**Amendment and Response**

Serial No.: 10/656,844

Title: RECLOSEABLE CARTON

Please replace FIG. 6 with new FIG. 6 shown in the attached Replacement Sheet. Attachments include one Replacement Sheet including changes to FIG. 6 and one Annotated Sheet showing changes to FIG. 6 in red.

Fig. 6

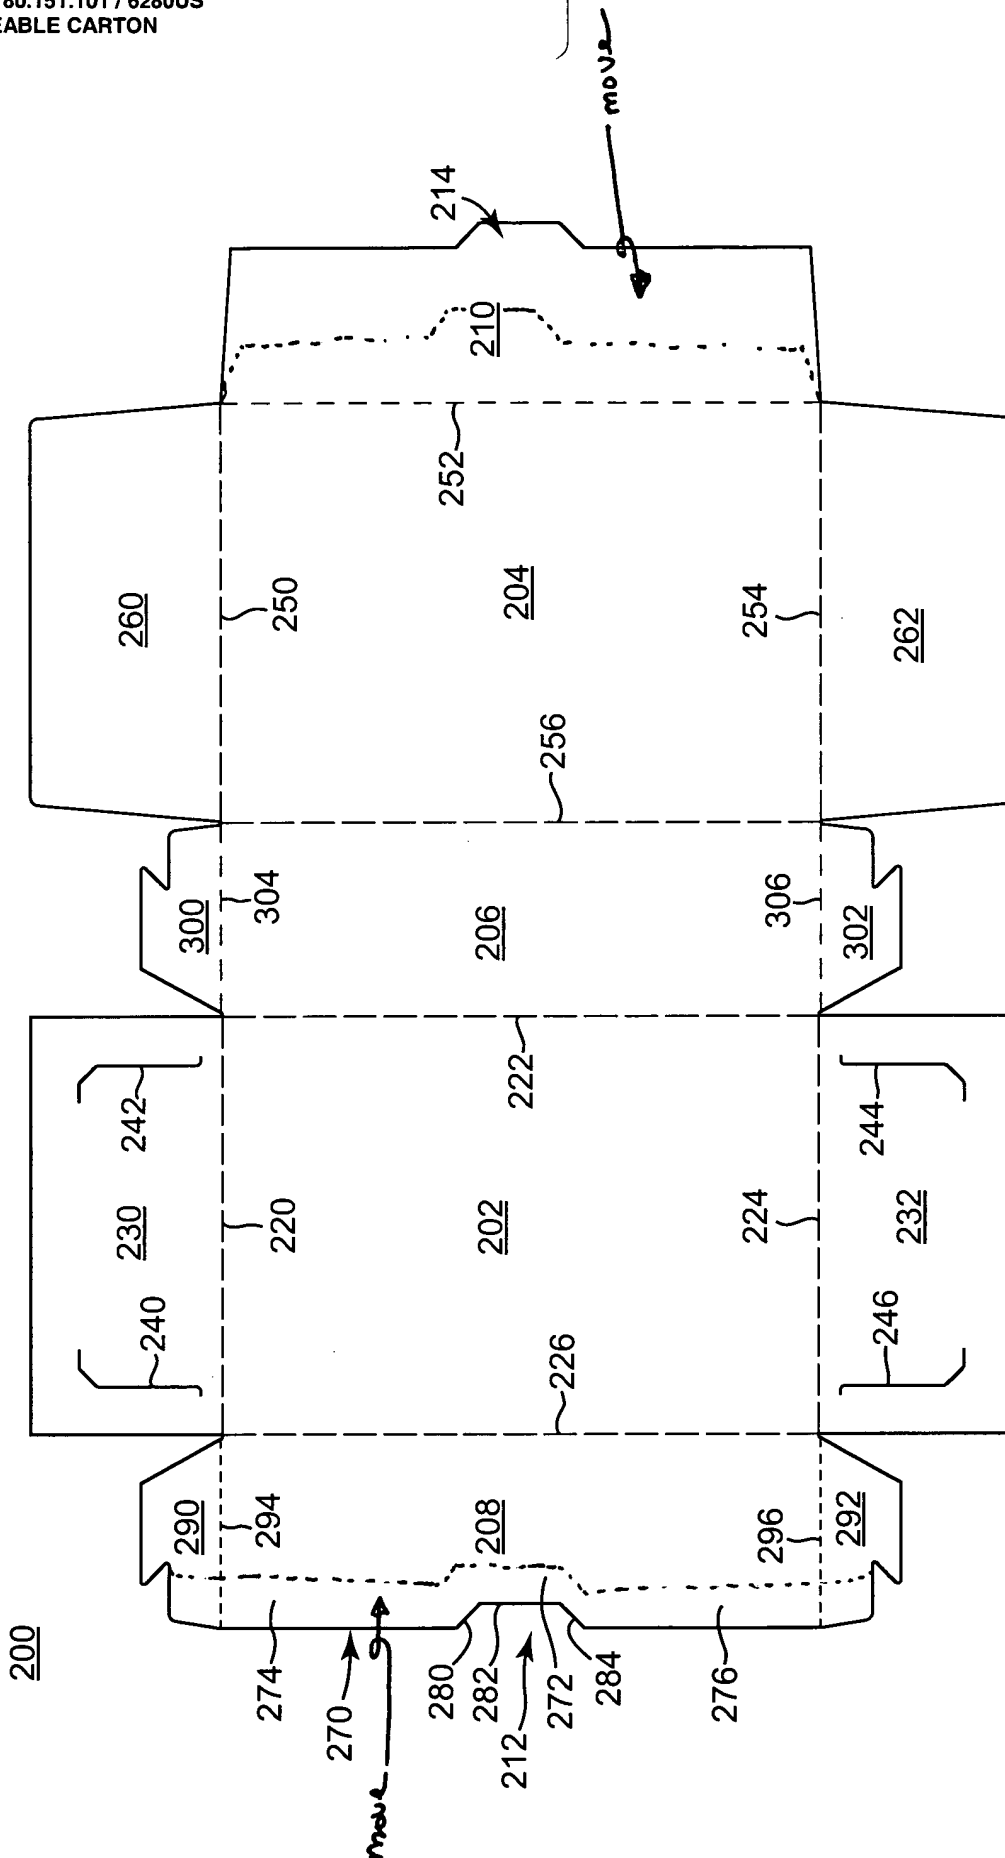
The embodiment of FIG. 6 as described on pages 12 and 13 of the specification is unclear with respect to how the tab 214 will interlock with the slot 212 when the carton is formed. It would appear that the tab 214 would be located adjacent the fold line 226 and that the slot 212 would be located adjacent the fold line 252. The specification provides no description of how the interlock and the carton formed from the blank of FIG. 6 is made.

The specification provides no description of how a box is made from the blank of FIG. 6 where the tuck slot 212 is adapted to receive the tab 214 as part of the reclosure operation.

As described in greater detail below, it is believed that the exact proportions of FIG. 6 are not limiting and the changes made are supported by the specification and figures according to the understanding of one of ordinary skill in the art. As such, the proportions of FIG. 6 have been modified in an effort to further clarify the application and expedite prosecution.

With the above tenants in mind, any incongruity presented by the dimensions of FIG. 6 is at least outweighed by (1) the presumption of an adequate description; (2) the remainder of the application, including the claims, detailed description, and other figures; and (3) the understanding that FIG. 6 does not show actual proportions.
